In Re Application: Tuy Vu Mai  
Serial No.: 10/664,737  
Filed: September 18, 2003  
Art Unit: 5612  
Examiner: Zaneli, Michael J.  
Title: **VEHICLE BASED DATA COLLECTION AND  
PROCESSING SYSTEM**

**RESPONSE TO OFFICE ACTION MAILED DECEMBER 07, 2004**

**Amendments to the drawings** begin on page 12 of this paper and include both an attached replacement sheet and an annotated sheet showing changes.

FIG. 1

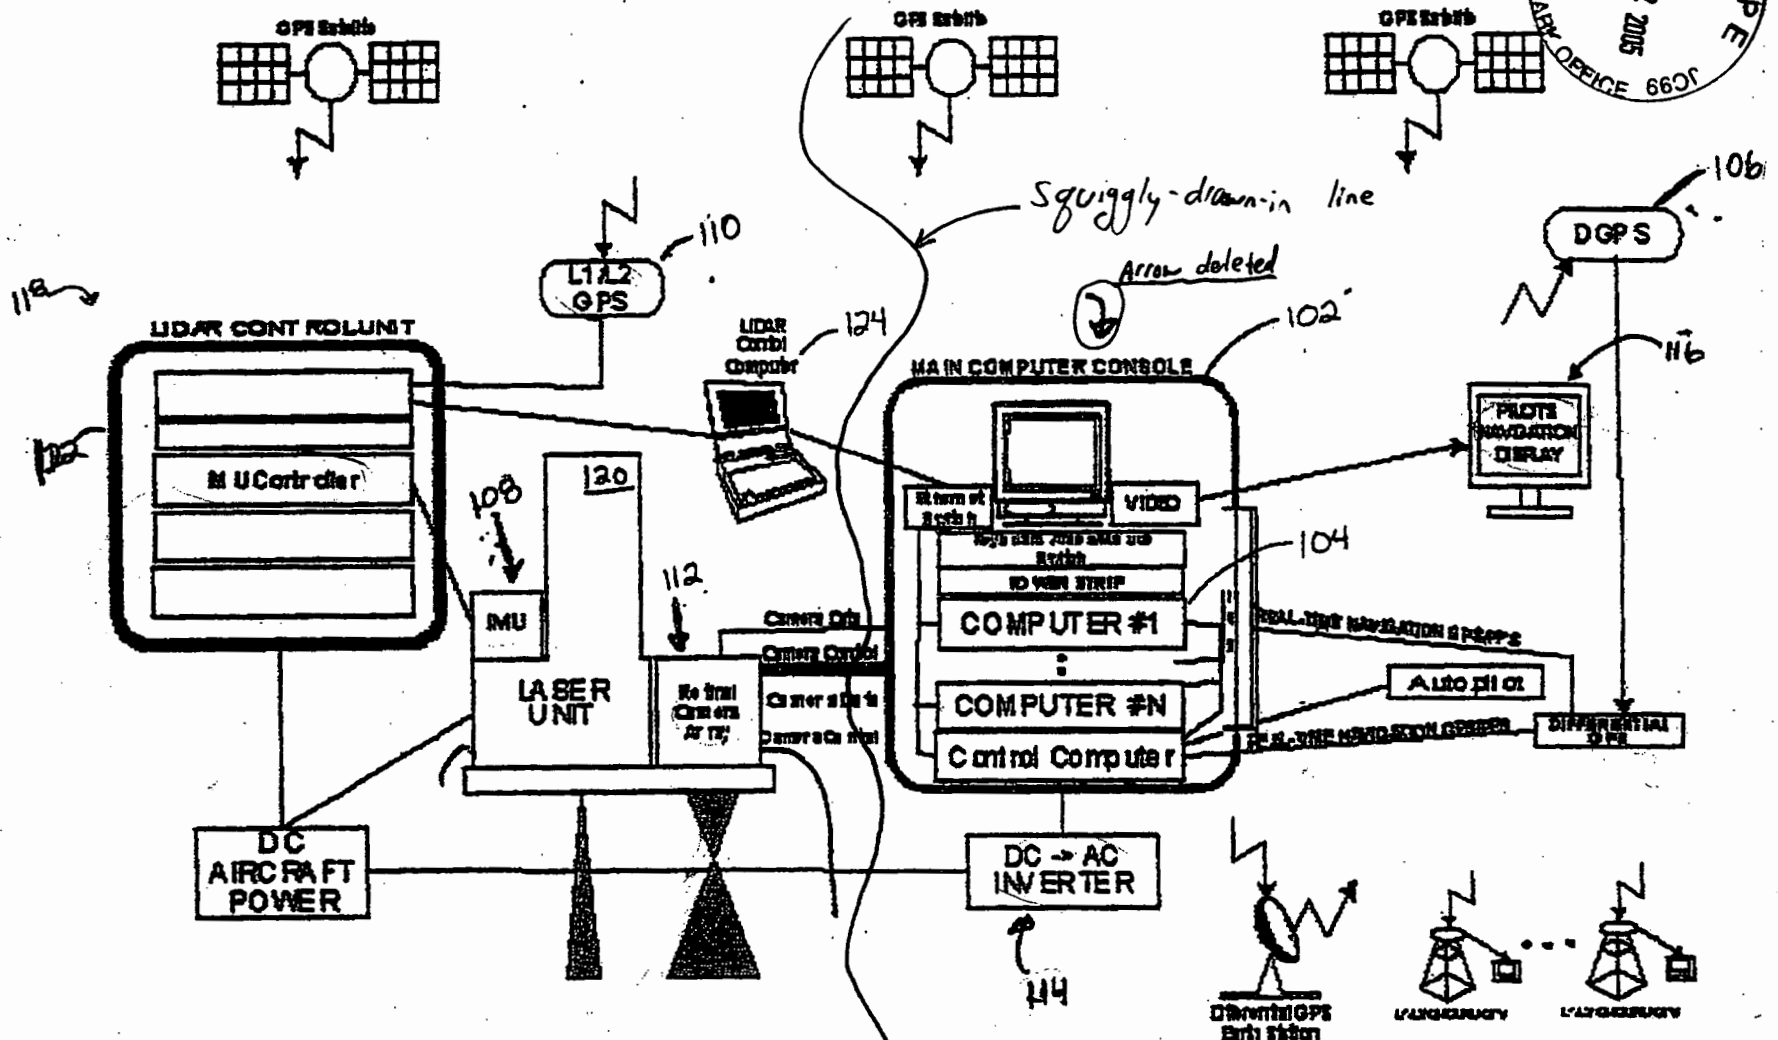
The attached sheet of drawings includes changes to Figures 1-18. The sheet that includes Figure 1 now replaces the original sheet that included Figure 1. In Figure 1, the lines connecting and identifying certain representational components have been repositioned for reasons of clarity. In Figure 1, the shape of the boxes have been changed and repositioned for reasons of clarity and stylistic preference. Additionally, Applicant has deleted some of the words in Figure 1, without prejudice and for reasons of clarity. No new matter has been added to Figure 1. Additionally, the arrow pointing to the block previously labeled “main computer console” has been deleted. Accordingly, Applicant respectfully requests the withdrawal of the objection to Figure 1.

In this application, Applicant has added new Figure 1A. Support for new Figure 1A is in the portion to the right of the squiggly-drawn-in line in annotated Figure 1. No new matter has been added to the specification as originally filed by including new Figure 1A.

In this application, Applicant has added new Figure 1B. Support for new Figure 1B is in the portion to the left of the squiggly-drawn-in line in annotated Figure 1. No new matter has been added to the specification as originally filed by including new Figure 1B.

FIG. 2

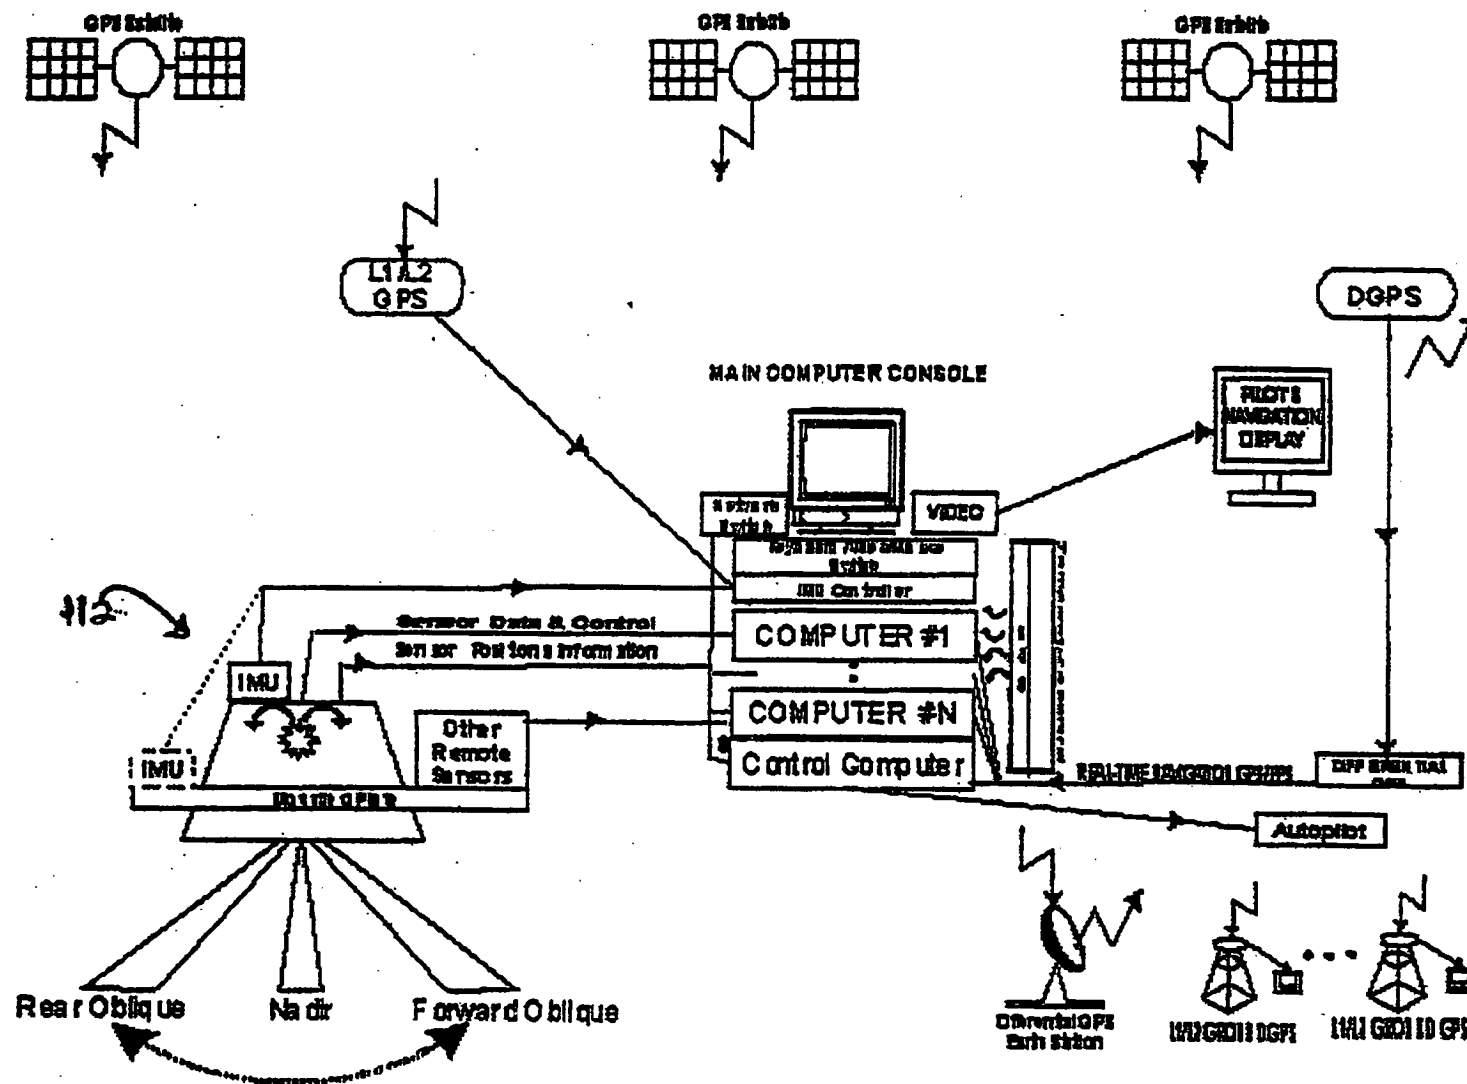
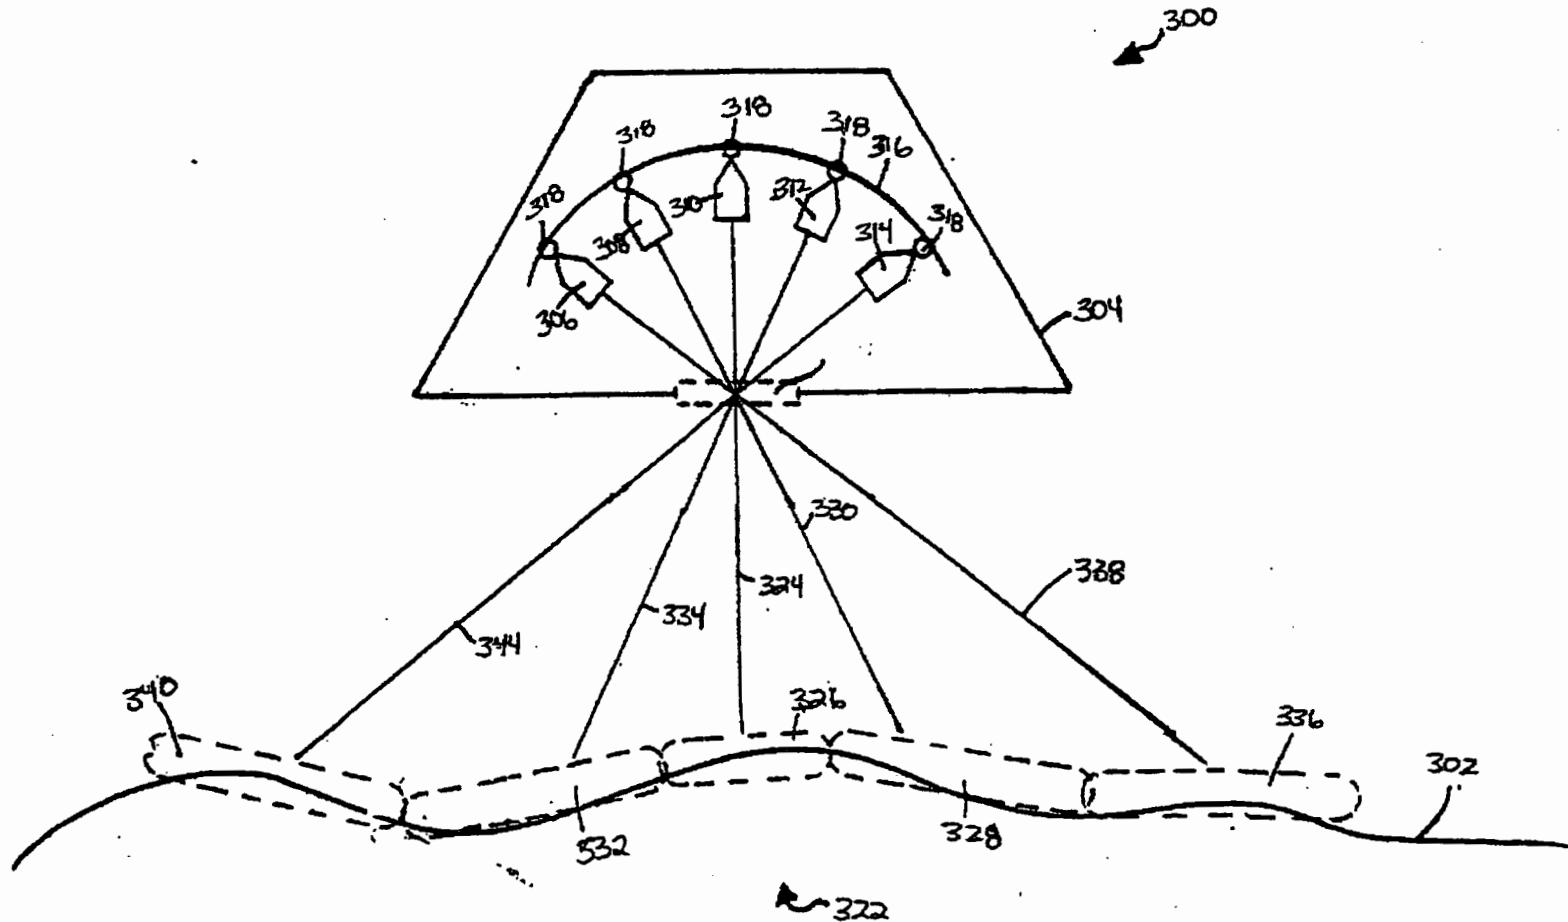
The sheets that includes Figure 2 now replaces the original sheet that included Figure 2. In Figure 2, the lines connecting and identifying certain representational components have been repositioned for reasons of clarity. No new matter has been added to Figure 2.

FIG. 4

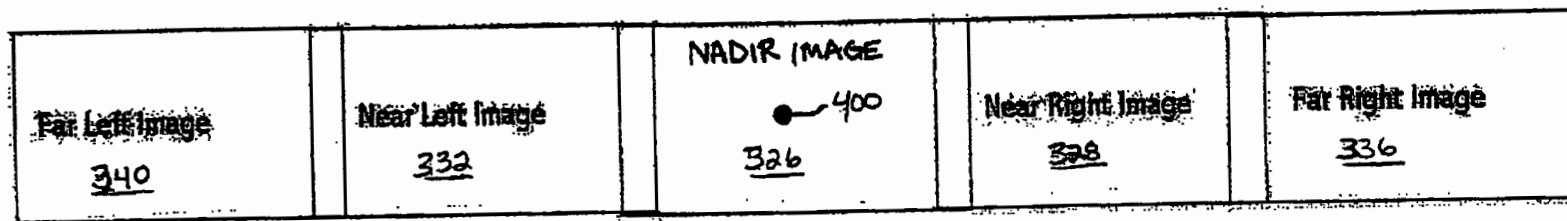
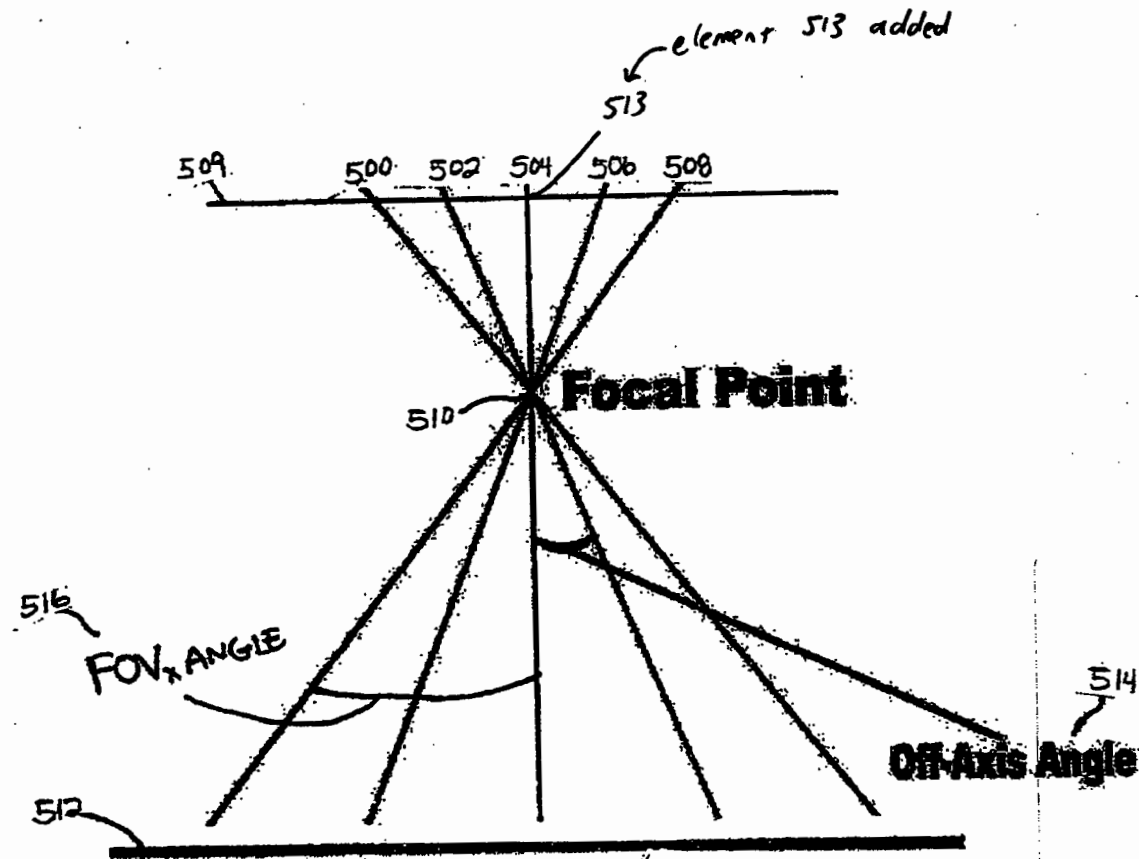
The sheets that includes Figures 3 and 4 now replaces the original sheet that included Figure 3 and the original sheet that included Figure 4. In Figures 3 and 4, the lines connecting

and identifying certain representational components have been repositioned for reasons of clarity. No new matter has been added to Figures 3 and 4.

FIG. 6

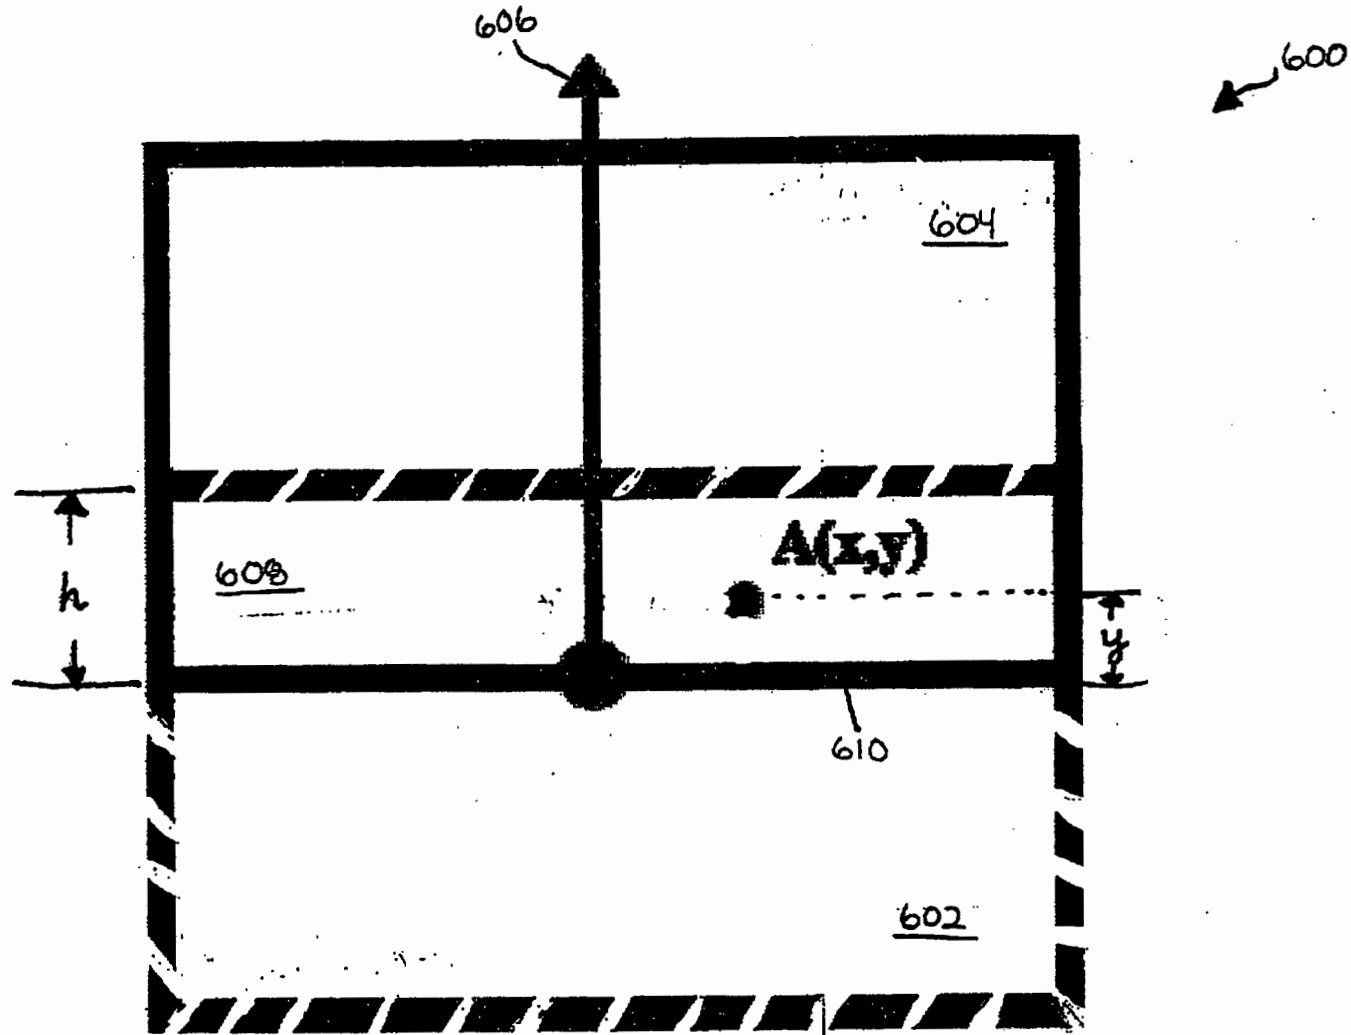
The sheets that includes Figures 6 and 7 now replaces the original sheet that included Figure 6 and the original sheet that included Figure 7. In Figures 6 and 7, the lines identifying certain representational components have been repositioned for reasons of clarity. No new matter has been added to Figures 6 and 7.

FIG. 8

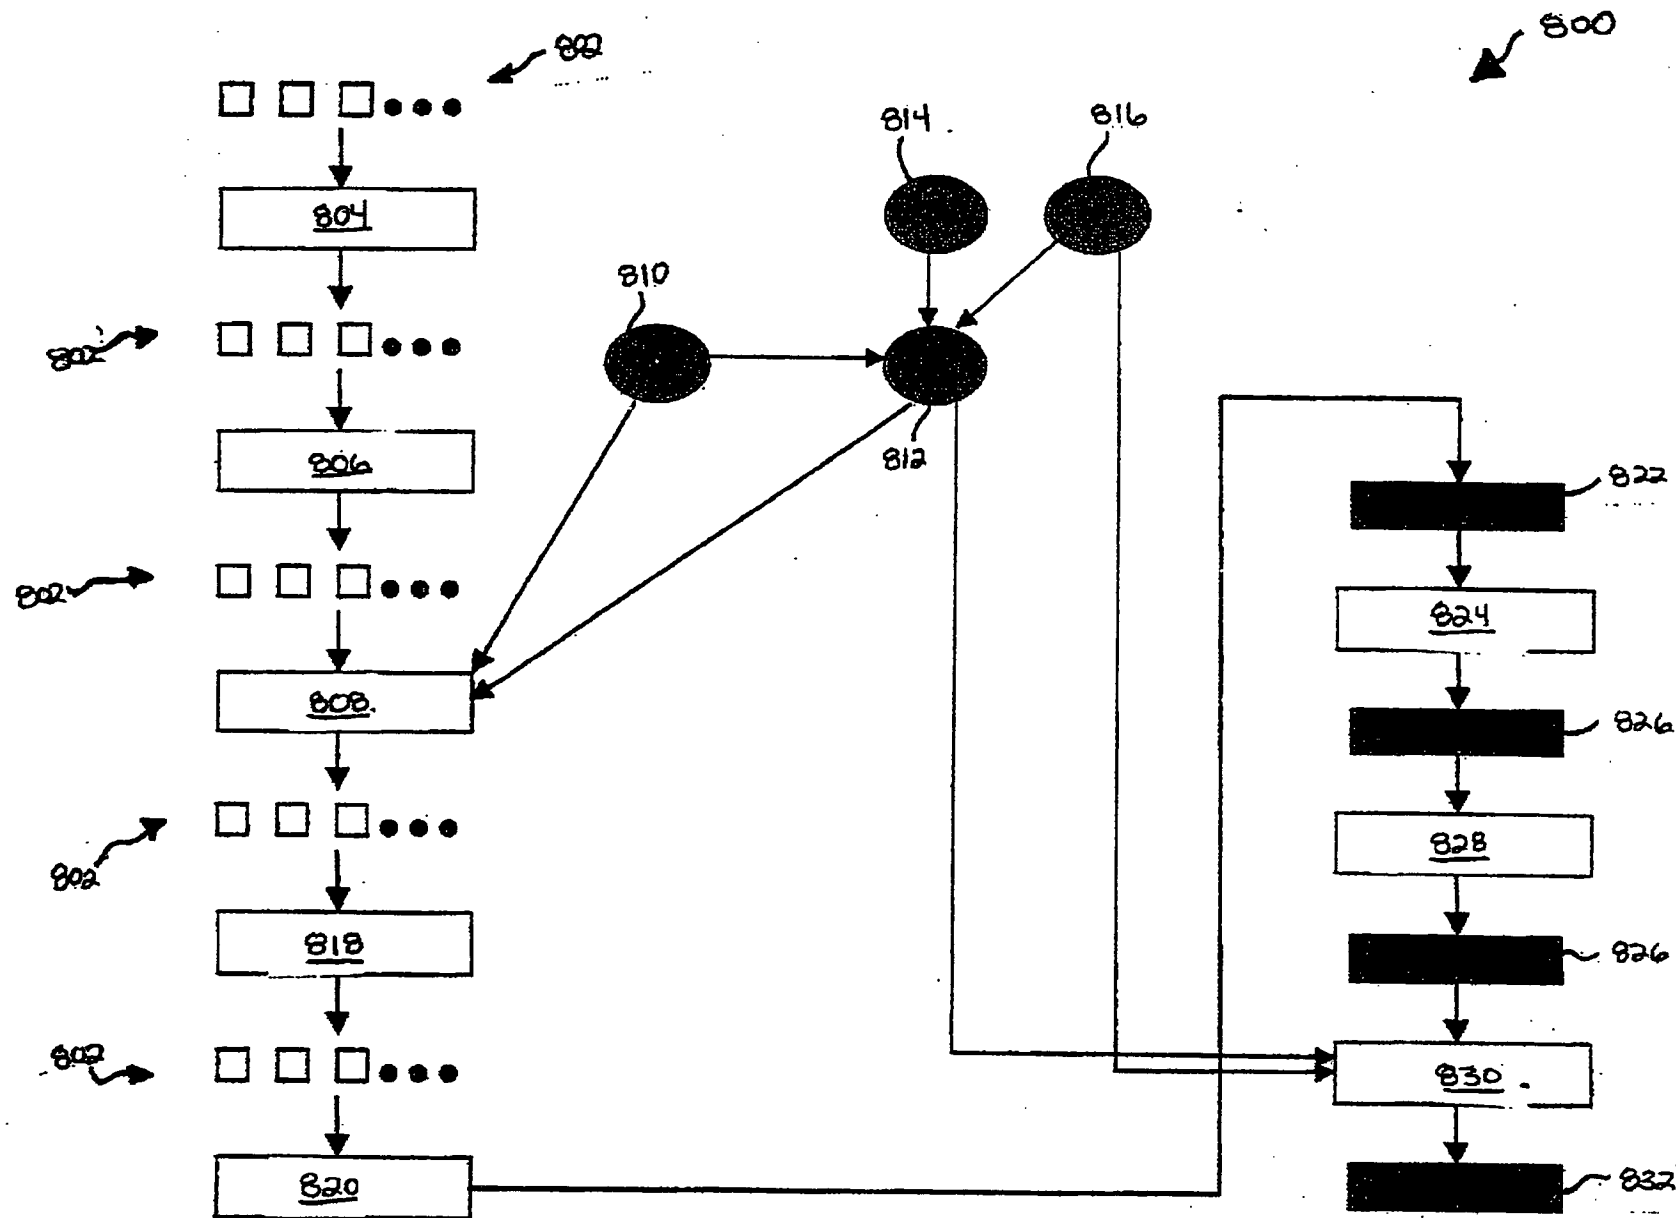
The sheet that includes Figure 8 now replaces the original sheet that included Figure 8. In Figure 8, the lines identifying certain representational components have been repositioned for reasons of clarity. No new matter has been added to Figure 8.
